CITY OF MAYVILLE UTILITIES COMMISSION
MEETING AGENDA
JUNE 22, 2026
5:00 PM
MAYVILLE CITY HALL
15 S. SCHOOL STREET

7.4. Discuss, with Possible Recommendation, Change Order #3

Project: Water/Wastewater Facility Upgrade

CHANGE ORDER NO.: 03

1 FIRE BARRIER TOP OF WALL DETAIL (ALIGN WITH ROOF PURLINS)
800A505 NONE

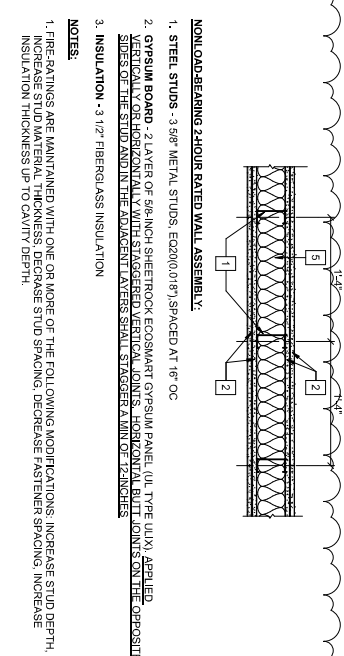
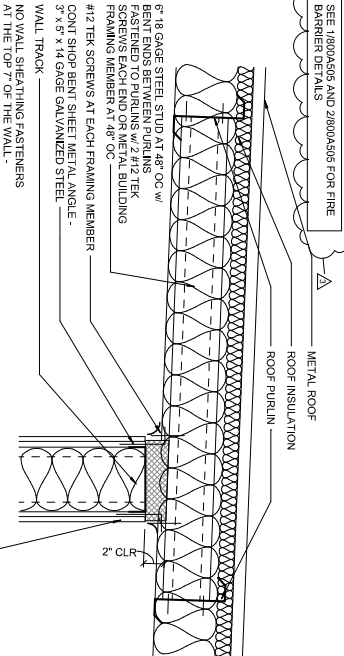
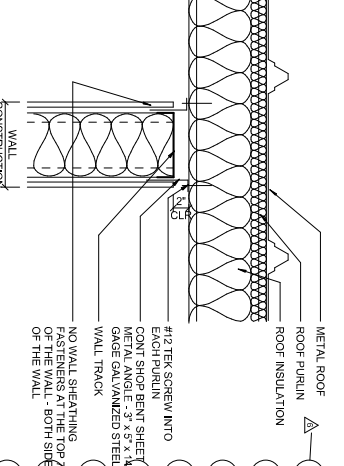
Revise Fire Barrier Wall Detail to Allow the Use of 3 5/8" Metal Stud and 2-Hour Rated Joint at Top of Wall

Revise fire barrier wall detail to allow the use of 3 5/8" metal stud and 2-hour rated joint at top of wall.

Revise fire barrier wall detail to allow the use of 3 5/8" metal stud and 2-hour rated joint at top of wall.

System No. **CJ-D-0032**

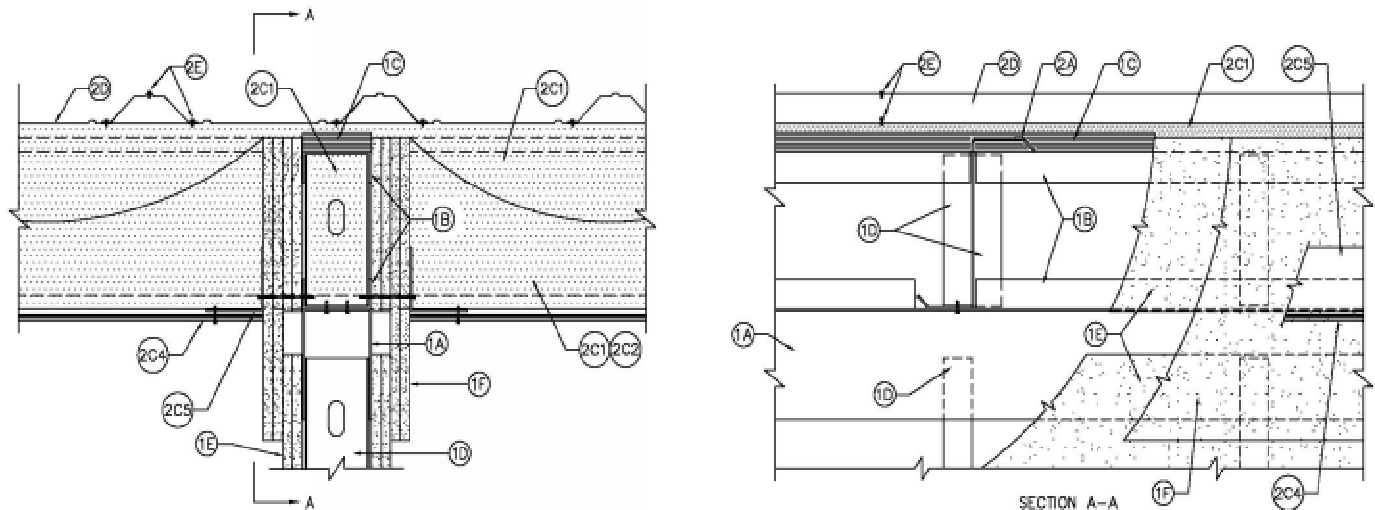
All firestopping shall be provided in accordance to specification section 07 84 00 - Firestopping. Details provide clarification for fire stopping locations and spacing for wall finish termination at the top of fire barrier.

8004504 3" = 1'-0" (22"x34") 0 1' 2' 3' 4' 1 1/2" = 1'-0" (11"x17")

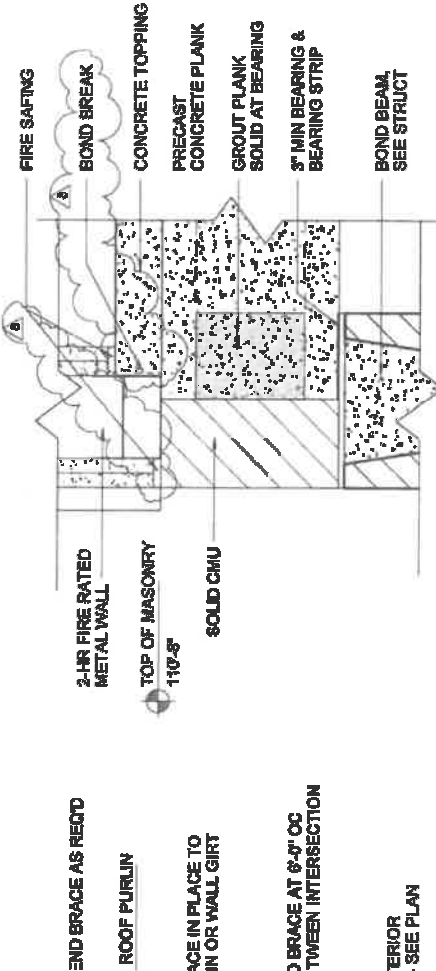
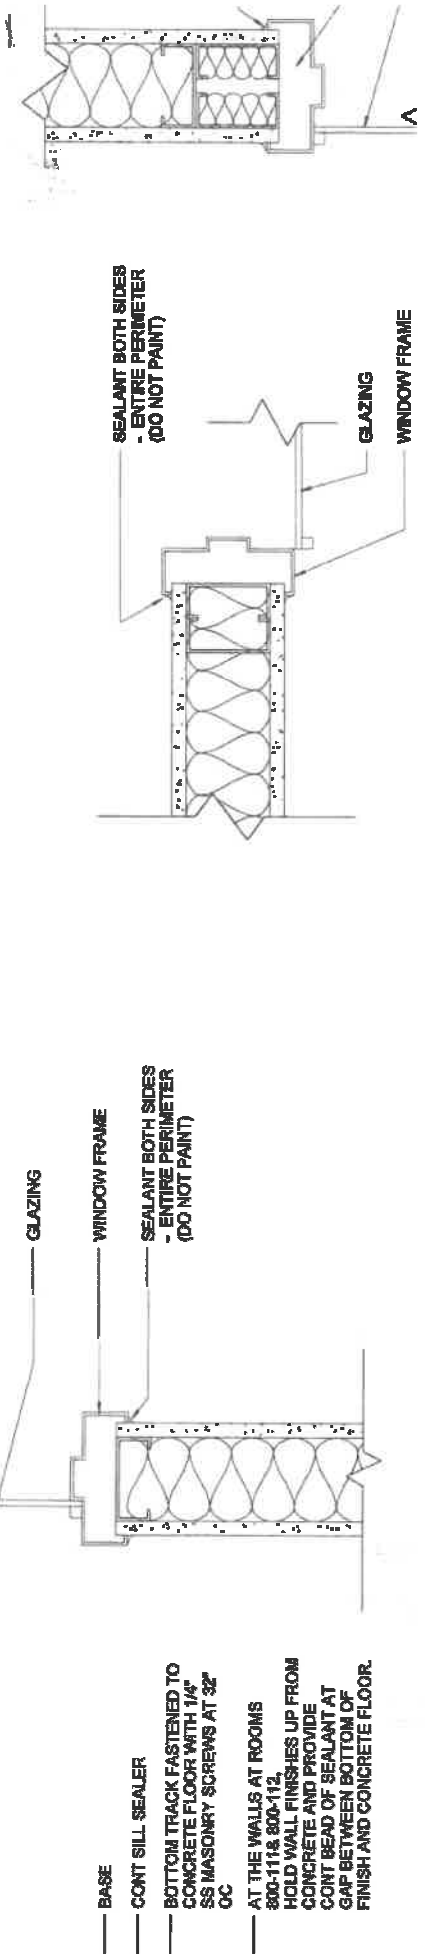
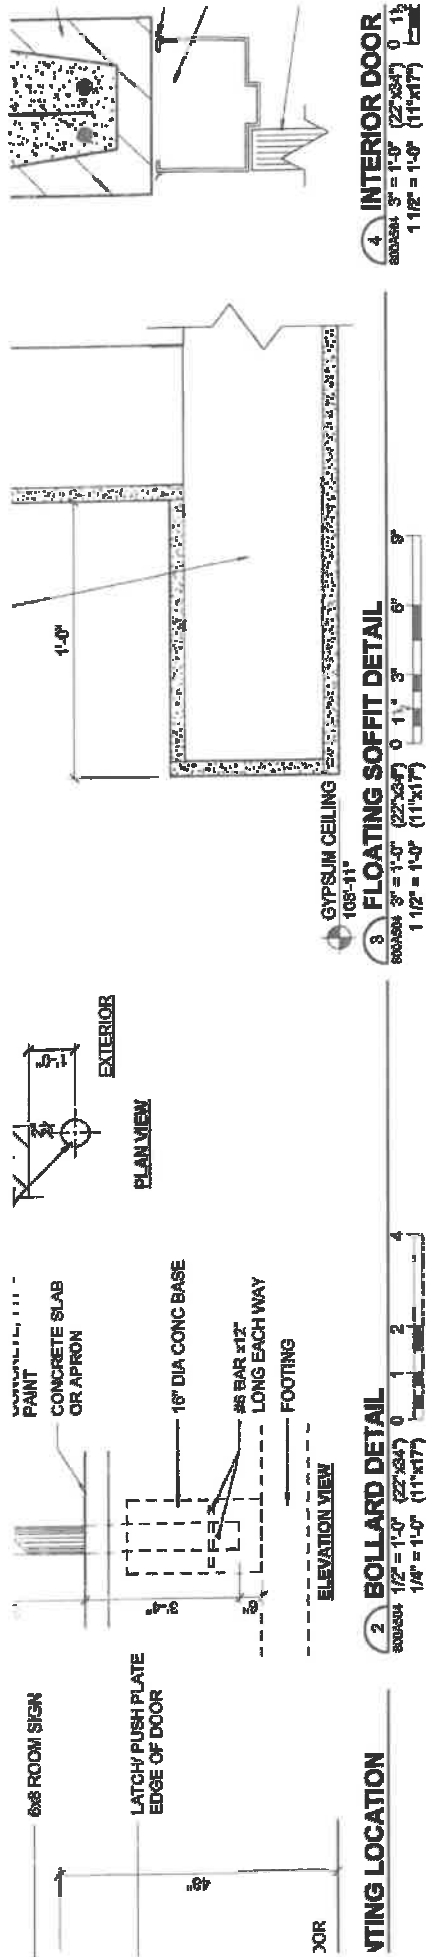
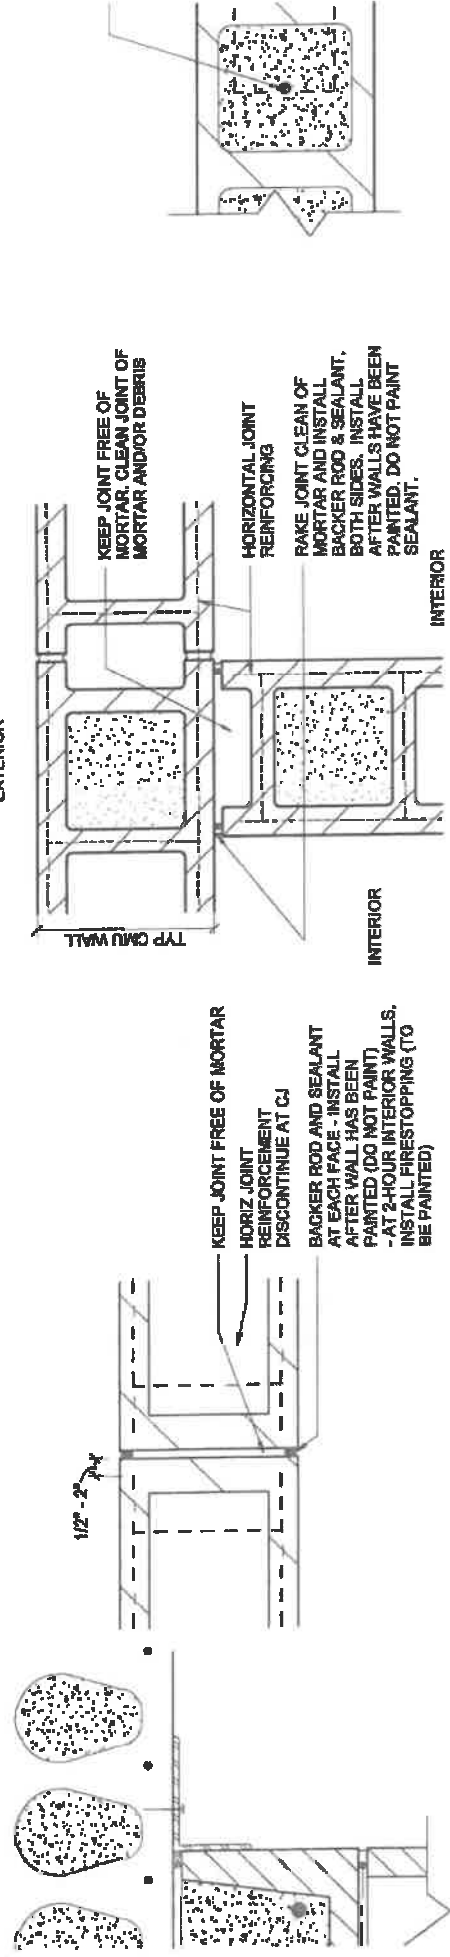
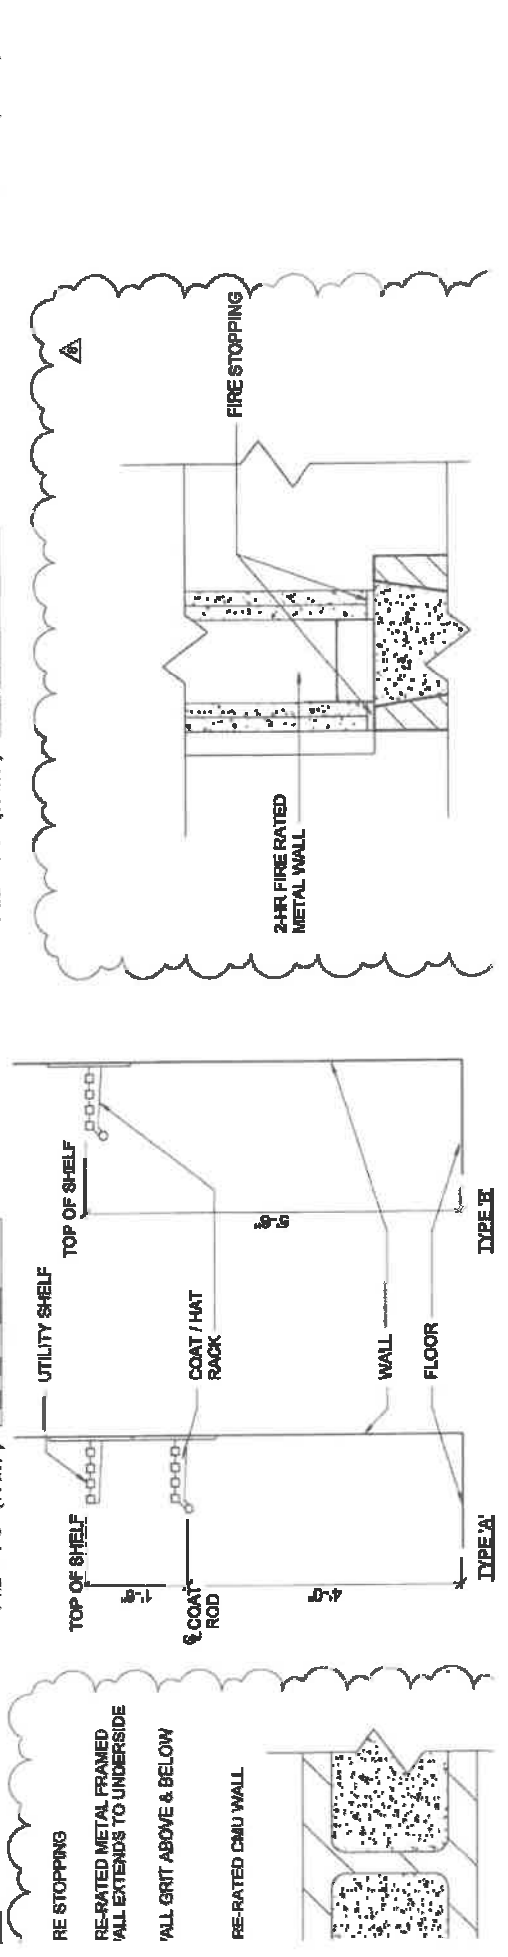
All firestopping shall be provided in accordance to specification section 07 84 00 - Firestopping. Details provide clarification for fire stopping locations and spacing for wall finish termination at the top of fire barrier.

ADMINISTRATION BUILDING ELECTRICAL PLAN

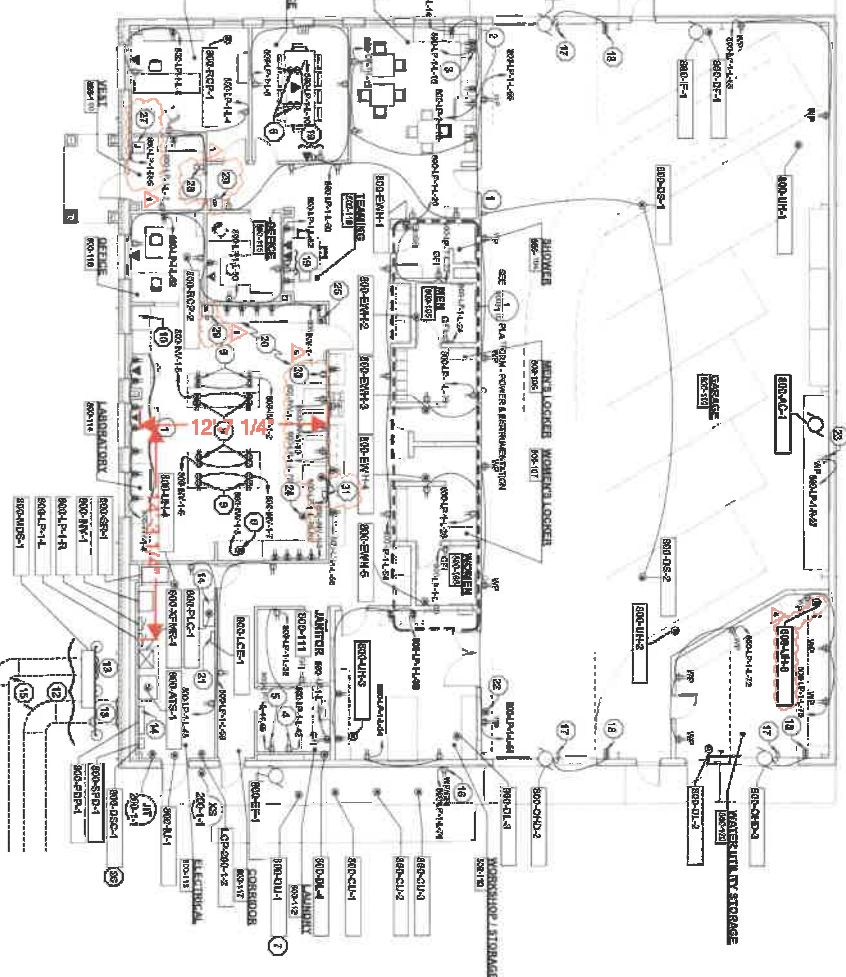
We discovered during our weekly jobsite meeting there is no power called out for any equipment along the north wall of the laboratory (see below). City of Mayville has indicated this area to have (2) incubators, (1) dishwasher, (1) refrigerator, and a DI/RO. We will need to know the electrical specifications of each piece of equipment, along with outlet locations. I can then work up a change order cost for the missing equipment.

Please refer to markups labeled RFI089 on sheets 800E101 and 999E603 attached to this RFI response for power requirements for the north wall laboratory equipment. Electrical Engineer will call Van Ert project manager to discuss change order on Thursday, January 29th.

FIELD ORDER NO.: 8

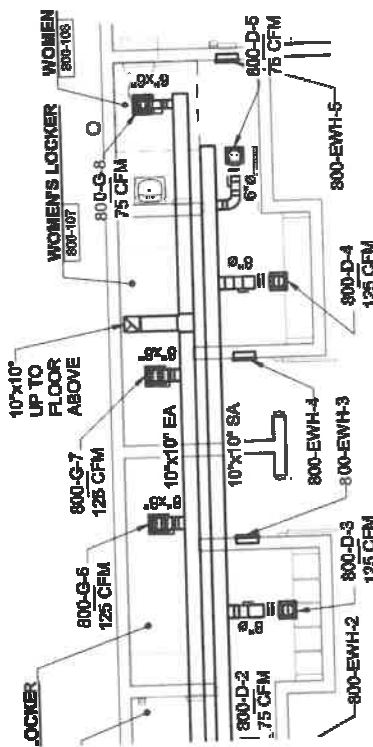
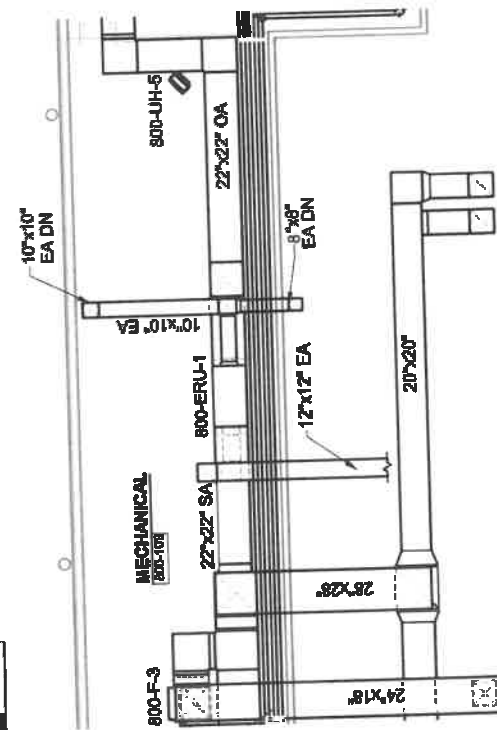
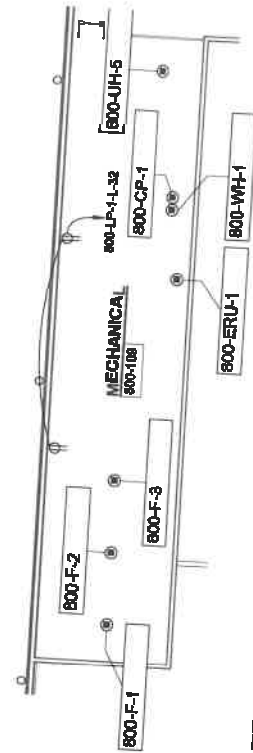
Provide clarification notes to HVAC and Electrical sheets relating to the TSS heater snorkel and fan as described 11 53 13 – 6. This includes updated drawings showing finalized duct routing, as well as penetration location. Associated electrical plans, schedules, and routing remain the same as FO 008.

Provide clarification notes to HVAC and Electrical sheets relating to the TSS heater snorkel and fan as described 11 53 13 – 6. This includes updated drawings showing preferred duct routing, as well as penetration location and associated electrical plans, schedules, and routing.

PROJECT NO.	00052025
	SHEET	800H101

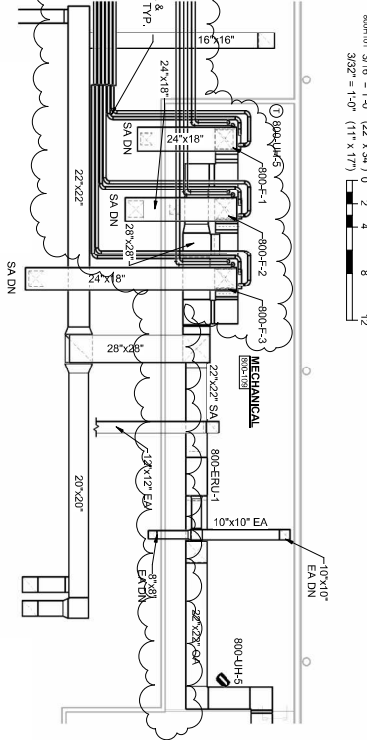
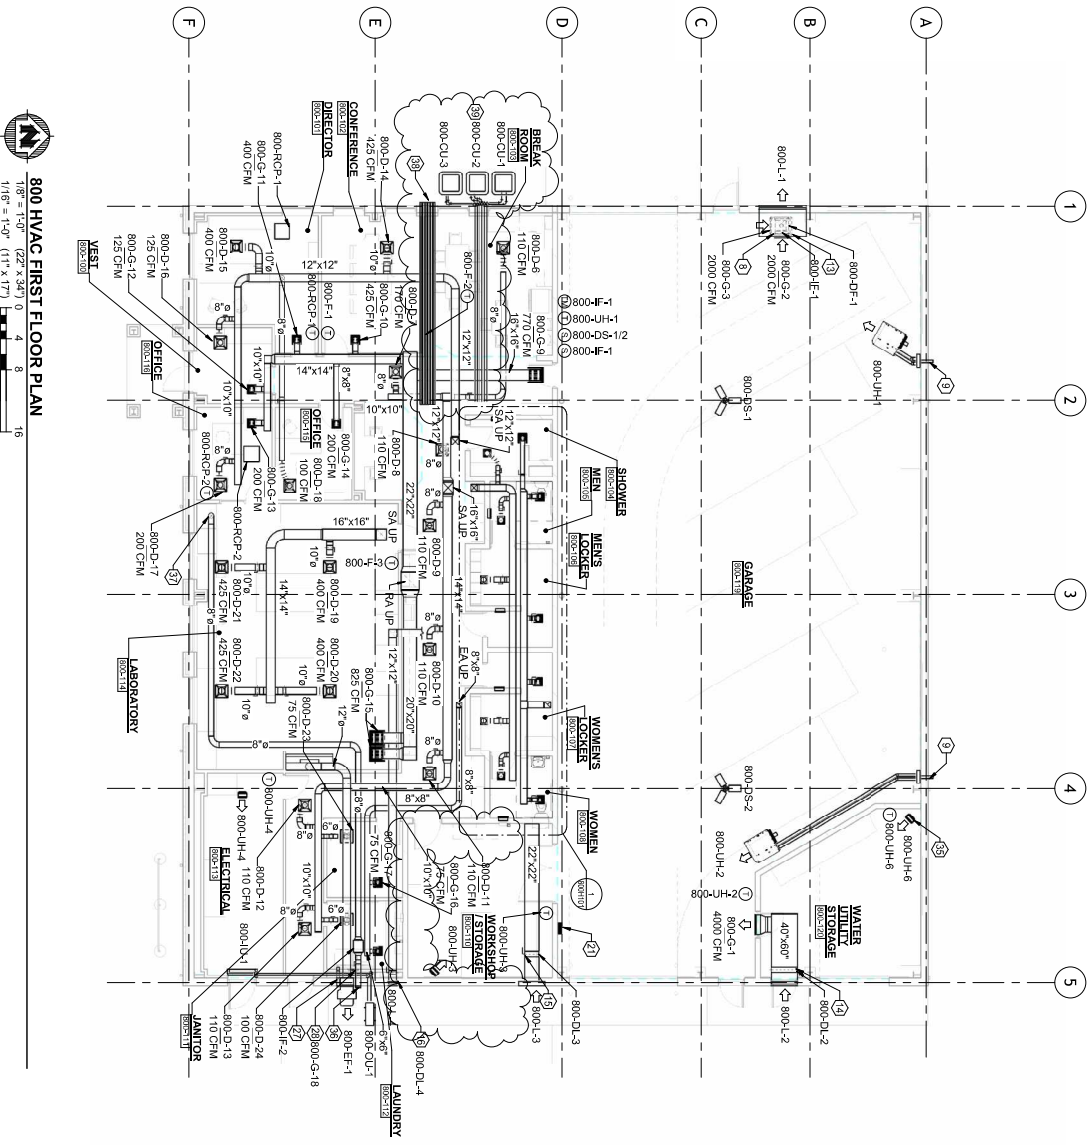
The purpose of the Work Change Directive is to summarize the suggested locations for furnace venting and condenser lines sets according to previous communication with the general contractor regarding RFIs 081, 097, 099 and previously submitted COR 019 & future COR 022. COR 019 and COR 022 should be issued with the modified lengths and provide options for the specified vent pipe vs the upgrade in material

Question	Question from Stacie Cherney August Winter & Sons, Inc. on Friday, Dec 19, 2025 at 10:50 AM CST Please provide a location to terminate the furnaces exhaust and combustion intake vent pipes. Please reference detail 999H501 detail 5. Would it be acceptable to have a side mount return air on the furnaces? With the height restrictions there is not enough room to mount the return air boxes on the bottom of the furnaces.” <i>Awaiting an Official Response</i>
All Replies	Response from Leslie Deuchars MSA Professional Services, Inc. on Tuesday, Dec 30, 2025 at 09:37 AM CST There appears to be space above the east door of corridor 800-117. Maintain clearance to any operable doors. Side mounting return air is acceptable.

Question	Question from Wendy Zeinert August Winter & Sons, Inc. on Wednesday, Feb 11, 2026 at 02:06 PM CST Since the project started, the state is updating the requirements for venting gas fired appliances and equipment. The UL 1738 venting system is expected to become the national standard in the near future. With that being said, we would normally use schedule 40 PVC to vent the appliances and equipment. We are still able to use PVC pipe and fittings, but if the code is updated in the future, any replacement of the equipment would also require replacing the venting to the new system. Should we still vent the water heater and furnaces with schedule 40 PVC, or get pricing for installing the new UL 1738 pipe and fittings?
	Awaiting an Official Response
All Replies	Response from Leslie Deuchars MSA Professional Services, Inc. on Thursday, Feb 12, 2026 at 01:40 PM CST Please get pricing for owner consideration.

Question	Question from Wendy Zeinert August Winter & Sons, Inc. on Tuesday, Mar 3, 2026 at 02:21 PM CST Please reference the attached drawing. Can the (3) furnaces refrigeration and vent piping be routed out the west wall? This location would be approximately 64' of linear feet which would get us inside of the acceptable OEM line lengths for the refrigeration piping and venting. This would also include relocating (3) condensing units and the concrete pad. Attachments RFI 22 attachment.pdf
Awaiting an Official Response	
All Replies	Response from Kerry Hackert MSA Professional Services, Inc. on Wednesday, Mar 11, 2026 at 02:05 PM CDT • Provide a diagram of proposed change for final approval and prior to installation. ◦ The furnace vents shall maintain a separation of 3 feet above or 10 feet horizontally from any operable windows or doors. ◦ The condensing units shall be moved to keep them out of view as much as possible from windows. The installation manual for the condensing units indicates that longer distances of refrigerant piping can be accomplished through contacting distributor or through Daiken Technical Publication TP-111. Moving the condensing units to the west wall shall be at no cost to the project unless these have been investigated and deemed not acceptable.
